**ONONDAGA LAKE CAPPING, DREDGING,
HABITAT AND PROFUNDAL ZONE (SMU 8)
FINAL DESIGN**

**ONONDAGA CREEK NAVIGATIONAL CHANNEL
DESIGN ADDENDUM**

AUGUST 2014

SUMMARY OF DESIGN REVISIONS

DET-6
Transition Between Dredging in Navigation Channel and
No Dredge Area Along CSX Shoreline
(TYP.)
Not to Scale

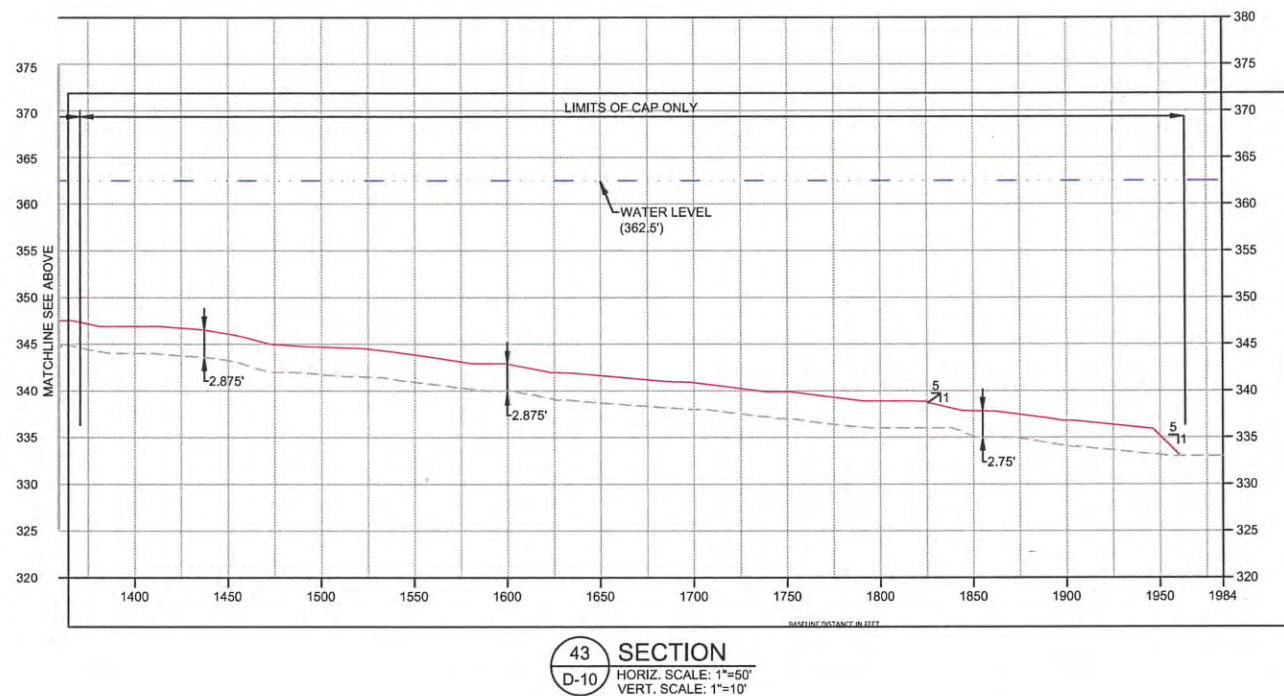
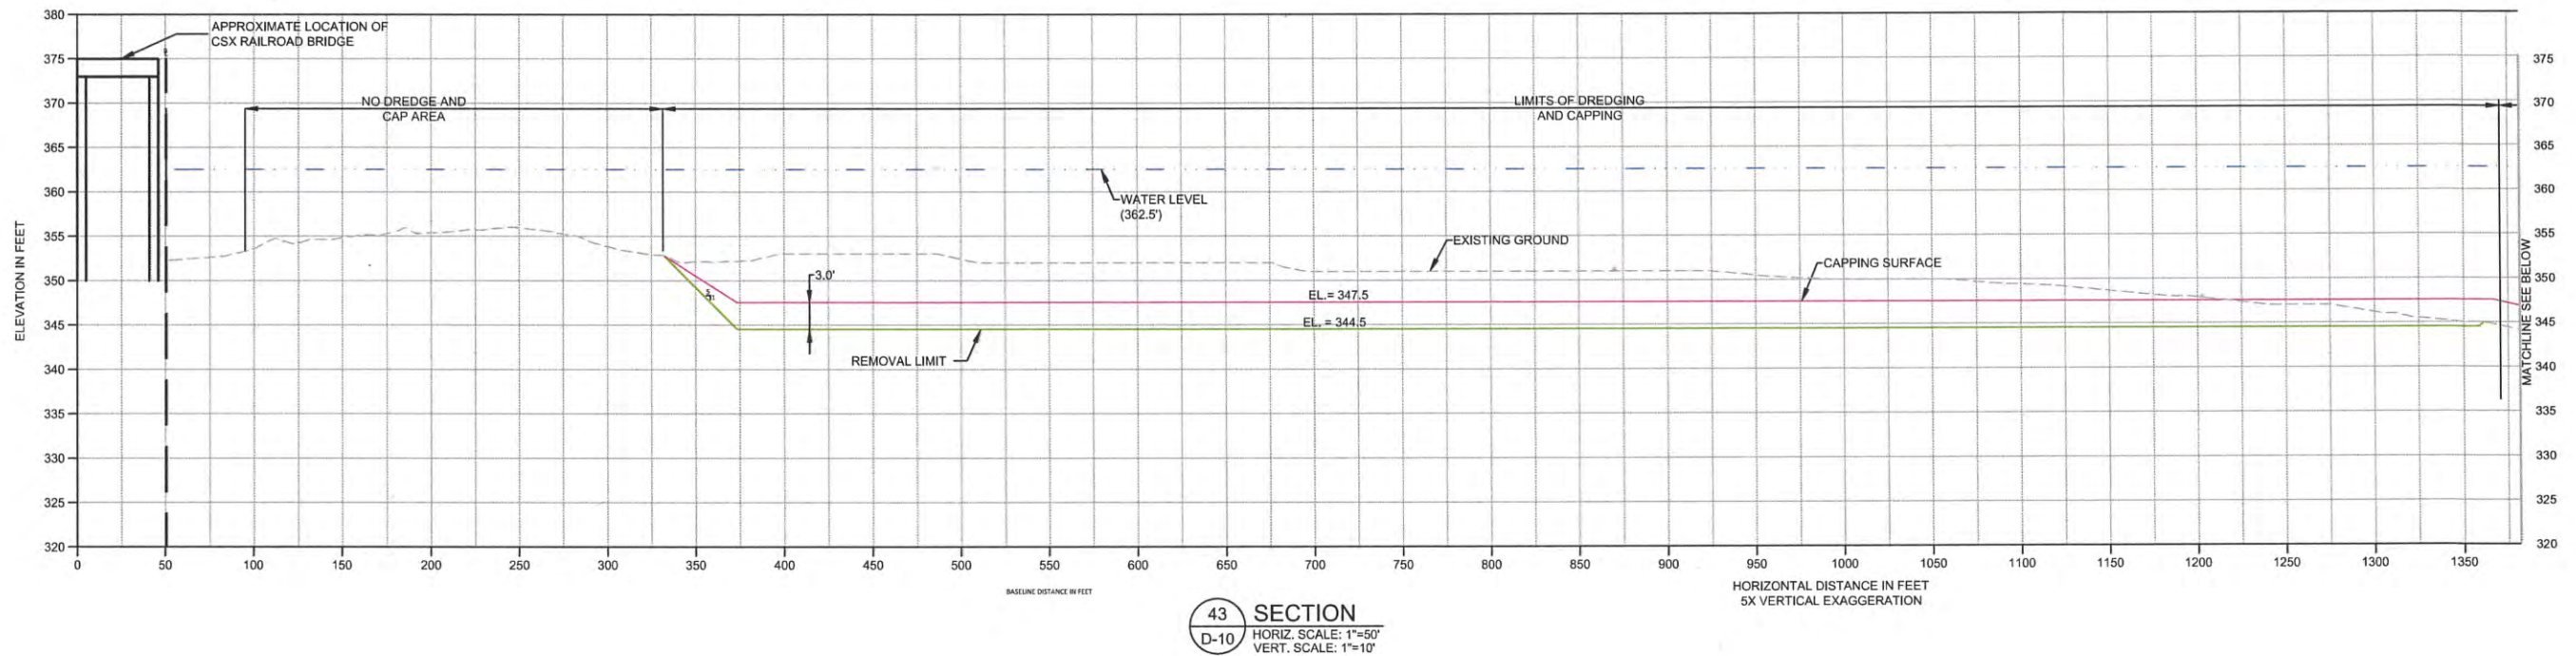
Three active rail lines are located immediately adjacent to the shoreline in the area of the navigational channel. Geotechnical analysis indicates that dredging adjacent to the shoreline in this area, including the navigational channel within this area, could result in an unacceptable factor of safety for the shoreline and rail line stability, which could result in movement of the rail lines. Therefore, no dredging or capping is included in this area within the navigational channel. The detailed evaluation documenting the basis for this offset is provided in the Technical Support Document for the Explanation of Significant Differences for this area.

REVISIONS				
REV	DATE	BY	APP'D	DESCRIPTION
0	03/05/12	WJD	JRV	ISSUED FOR CONSTRUCTION
1	08/07/13	WJD	JRV	ADDED CULTURAL RESOURCE A13 AND 25-FT NO CAP BUFFER
2	08/06/14	WJD	JRV	REVISED REMEDIATION AREA E
